RE: Phased Subdivision Application for 6719 Devon Avenue SE (AMANDA 20-118048-LD)

PW Completeness Review_Civil Plans_Devon Estates.pdf Markup Summary

P403

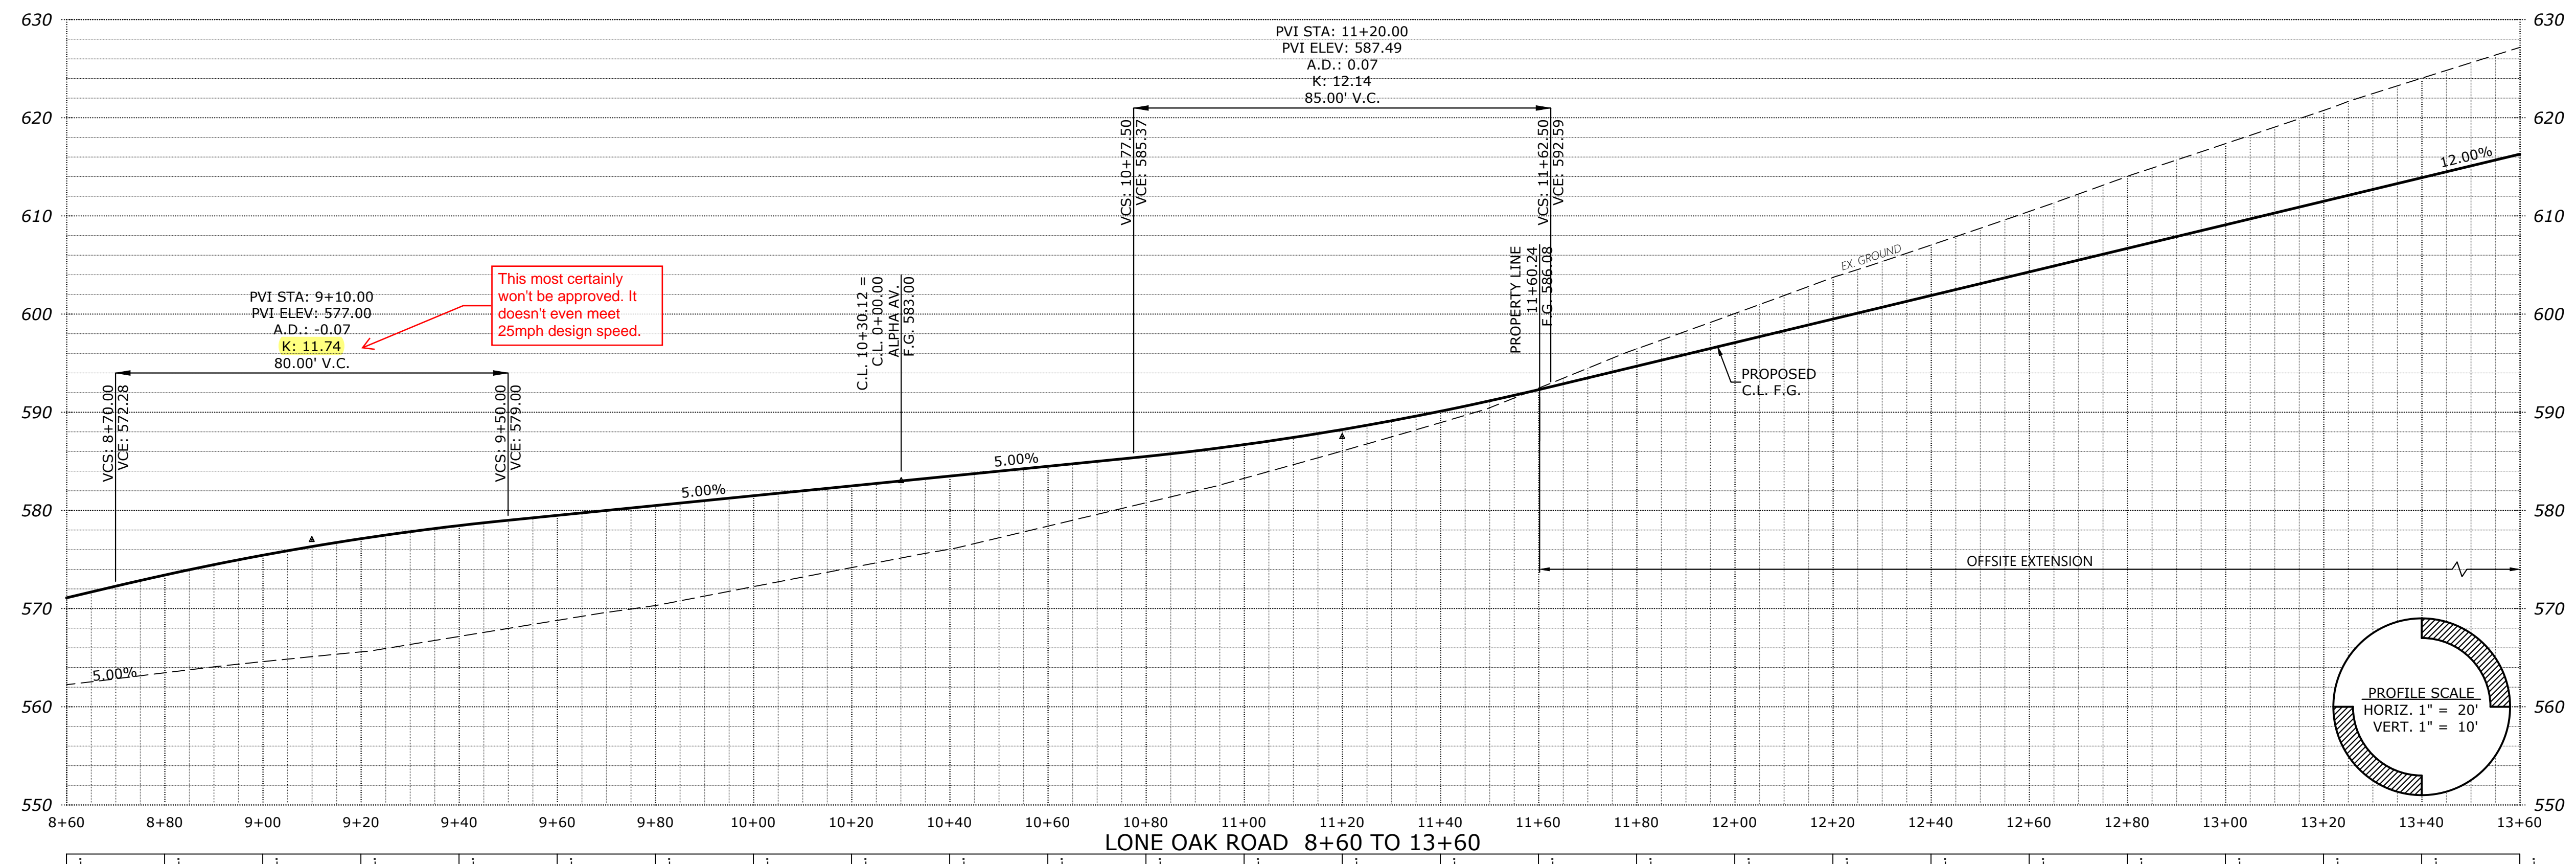
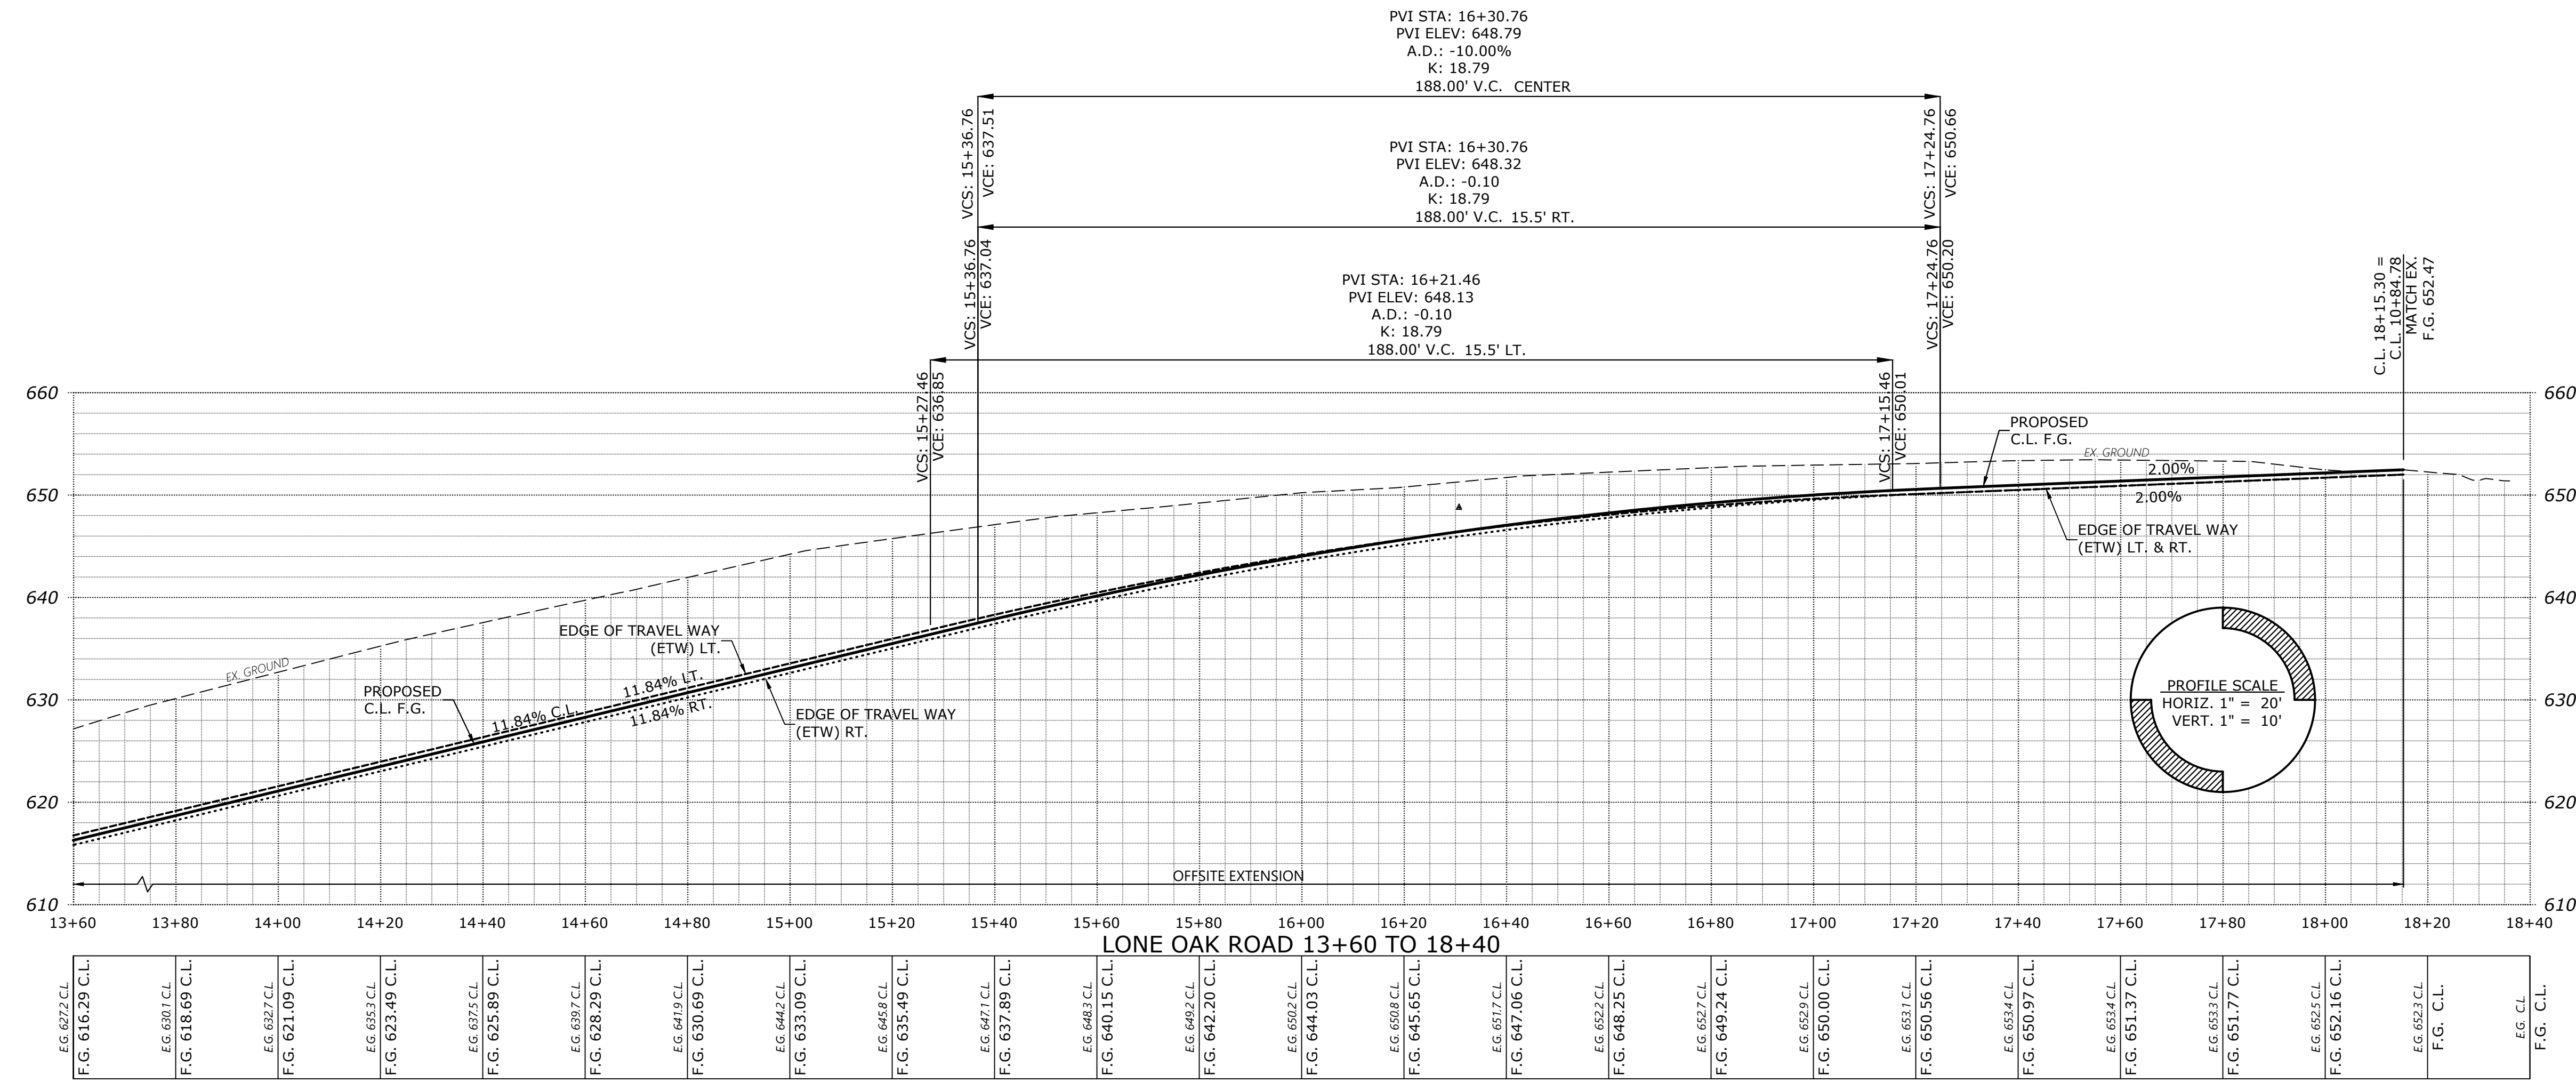
This most certainly won't be approved. It doesn't even meet 25mph design speed.

These ped crossing alignments won't be approved.

These ped crossing alignments won't be approved.

This most certainly won't be approved. It doesn't even meet 25mph design speed.

P405

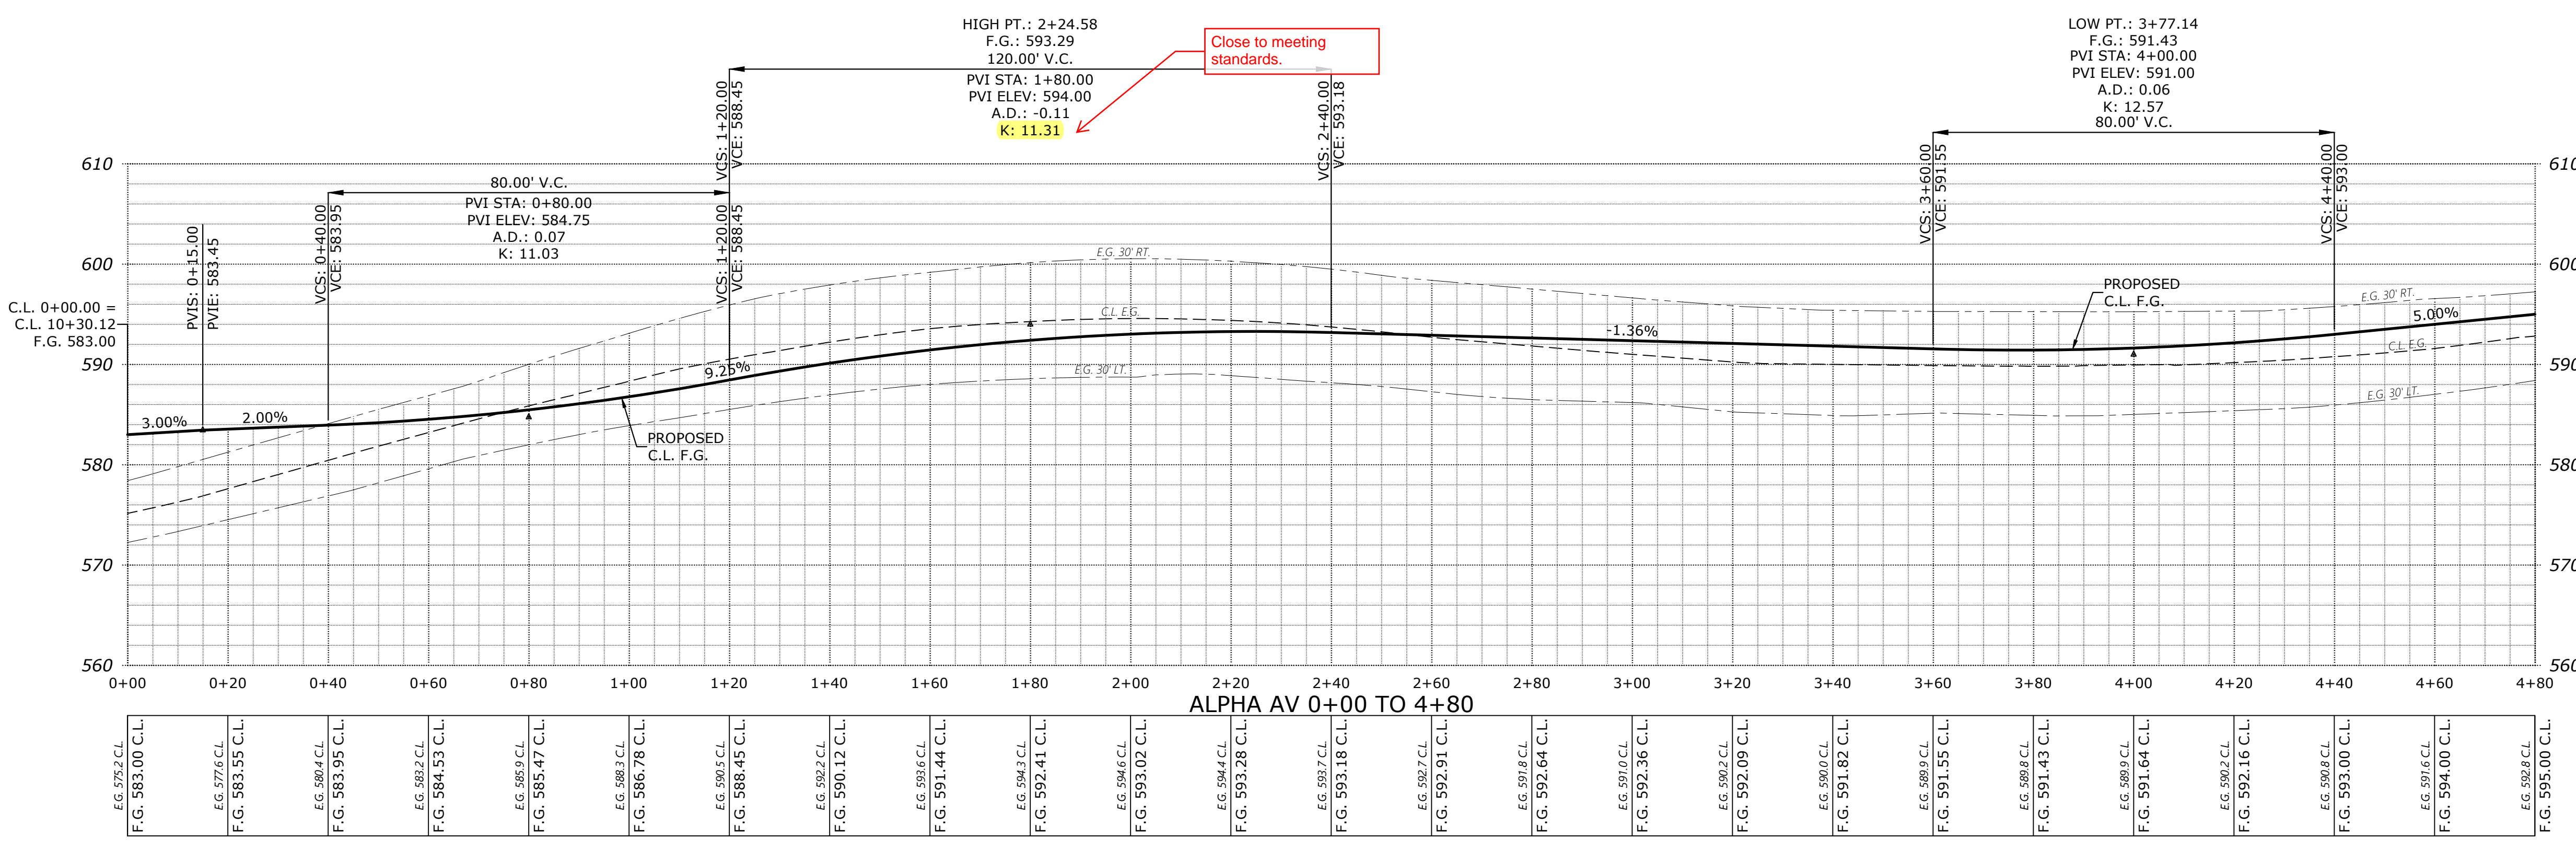
Design Exception required for horizontal curve.

Non-standard sidewalk location

Close to meeting standards.
